ADDENDUM NO. 2

**New Premium 63 Site Loop Campground
St. Francois State Park
Bonne Terre, Missouri
PROJECT NO.: X2317-01**

August 29, 2025

PLUMBING RISERS
AND DETAILS

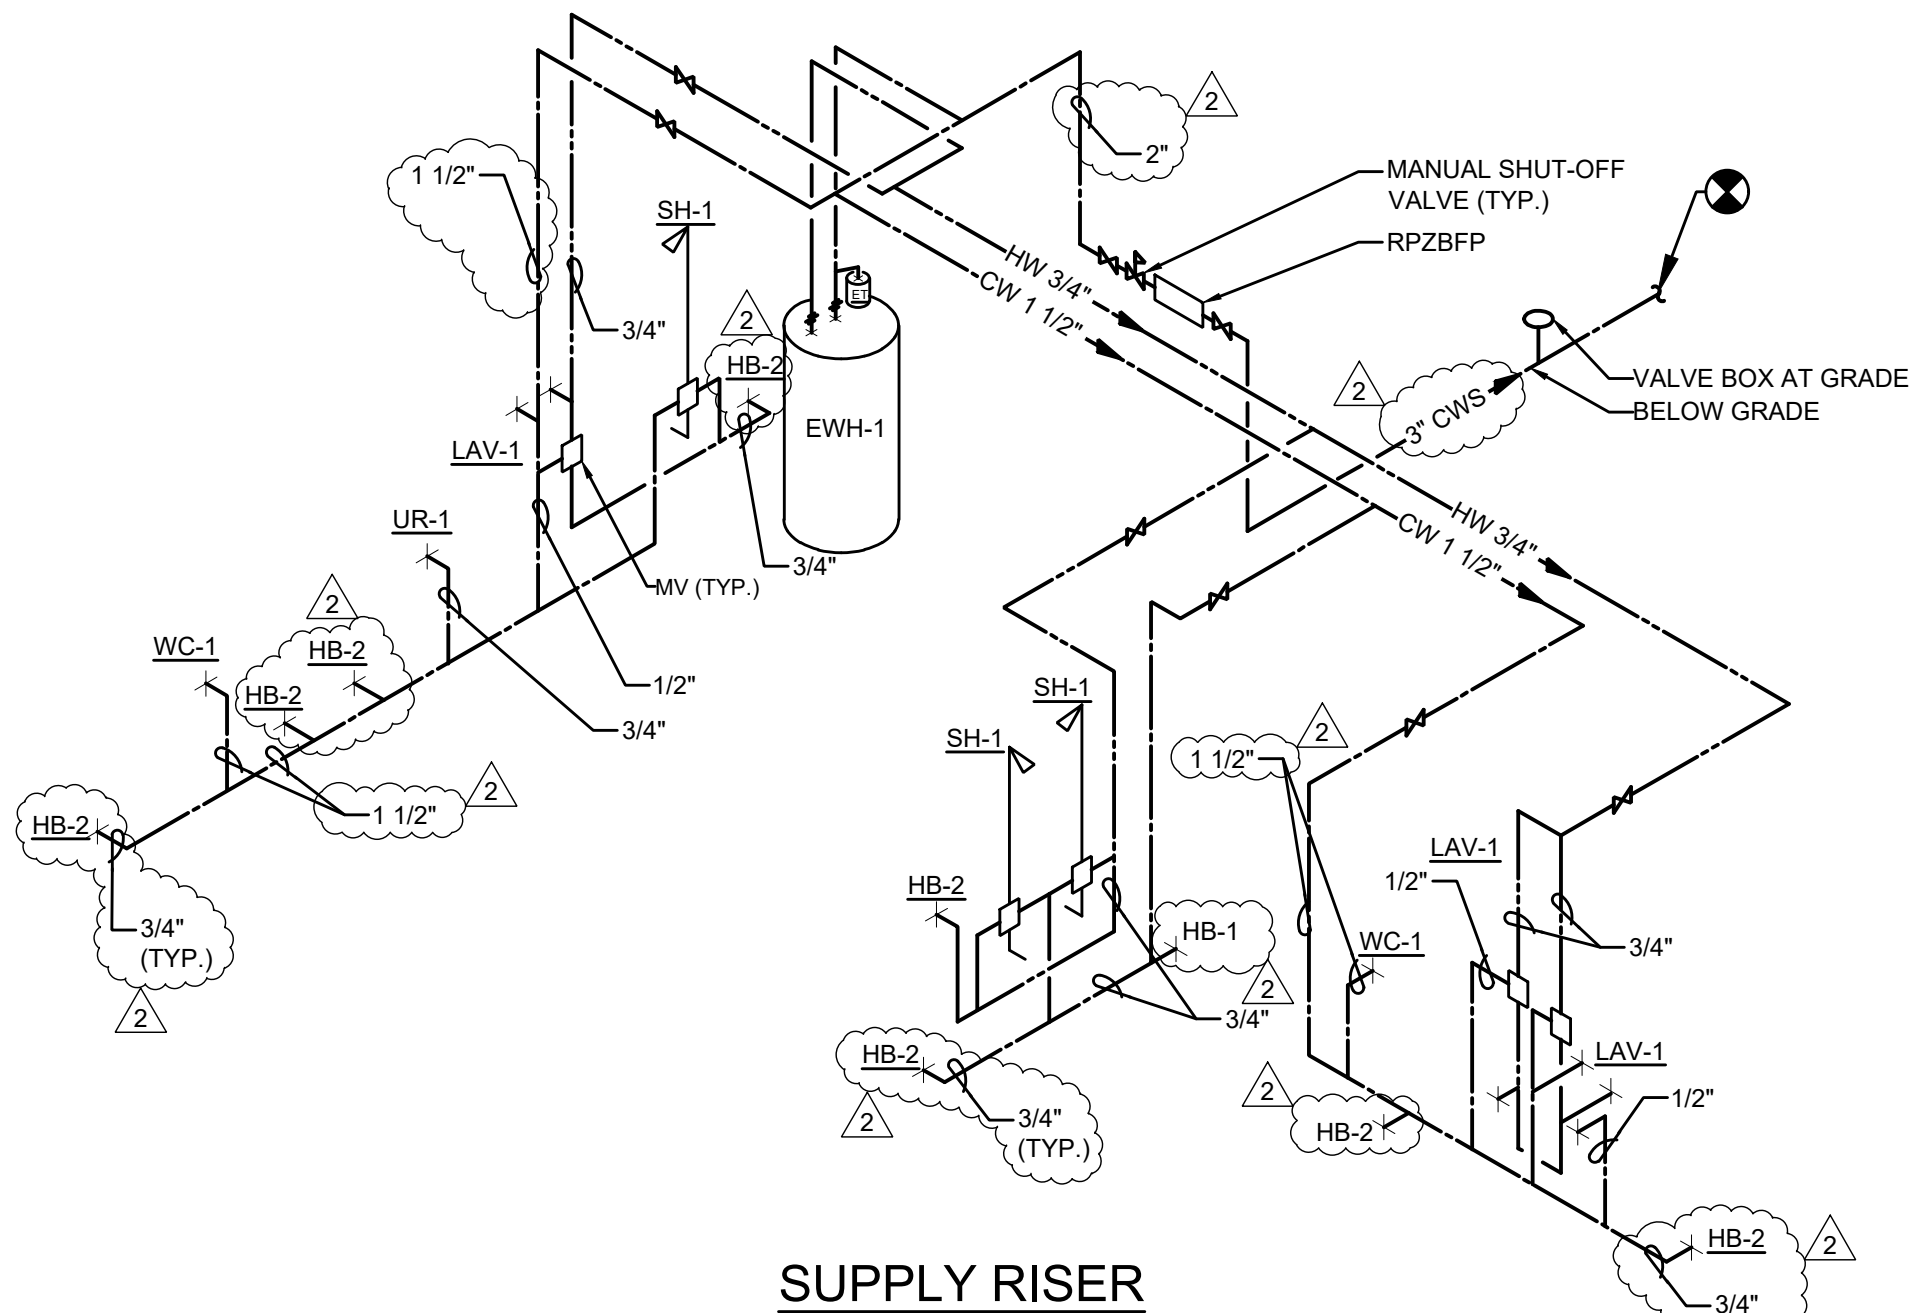
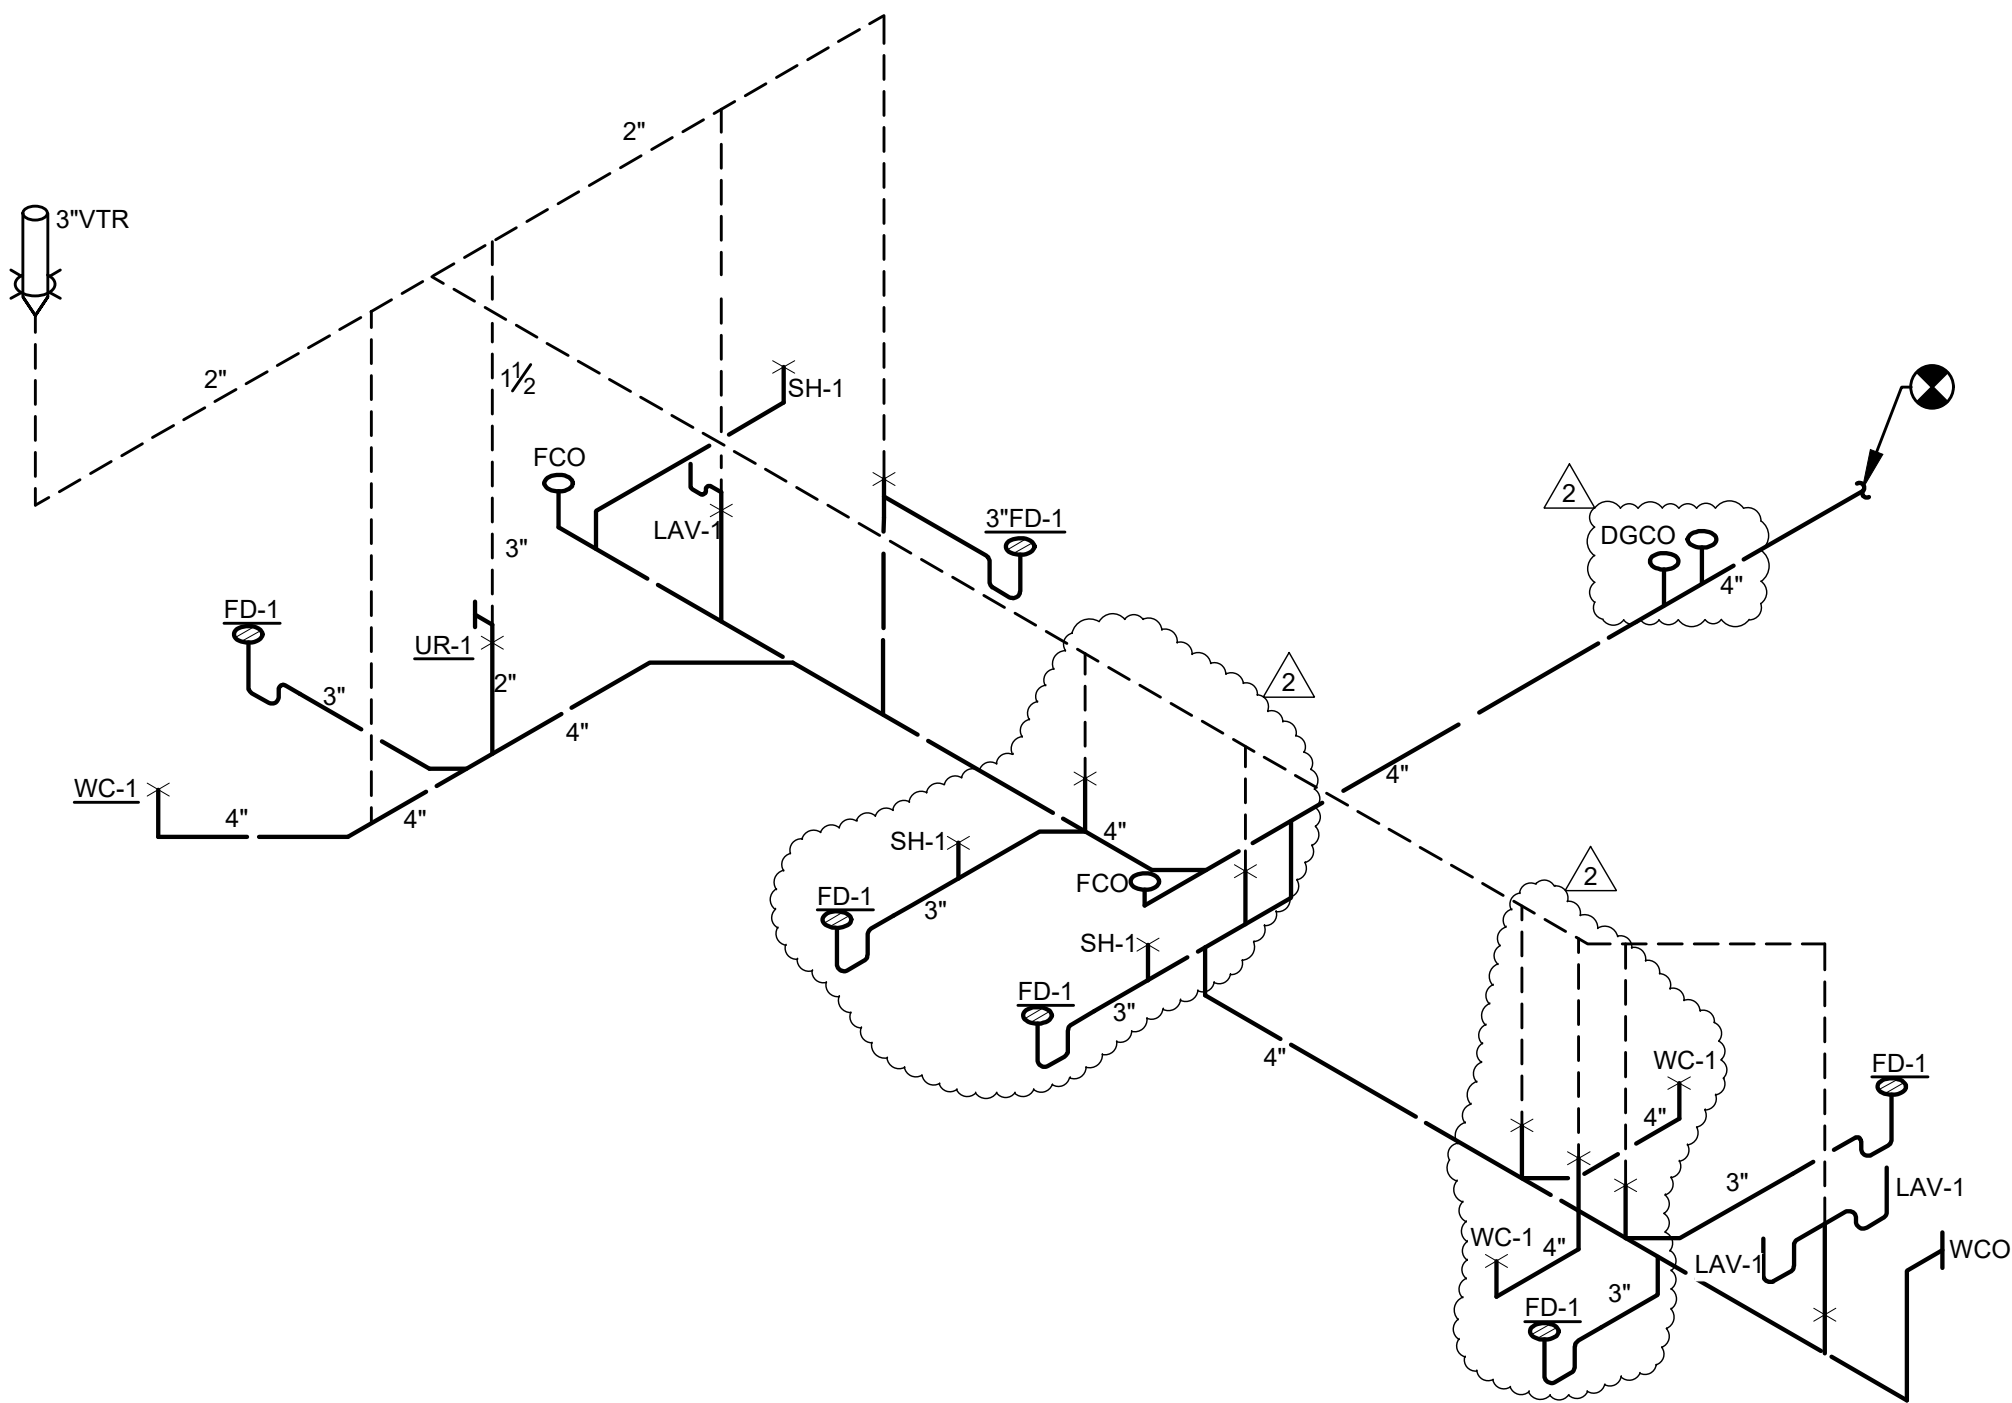
1. Added Water Heater detail.
2. Revise pipe size on supply riser.
3. Revised hose bibs (HB-2) on supply riser.
4. Revise sanitary and riser layout to match plan.
5. Added double clean out to exterior piping on riser.
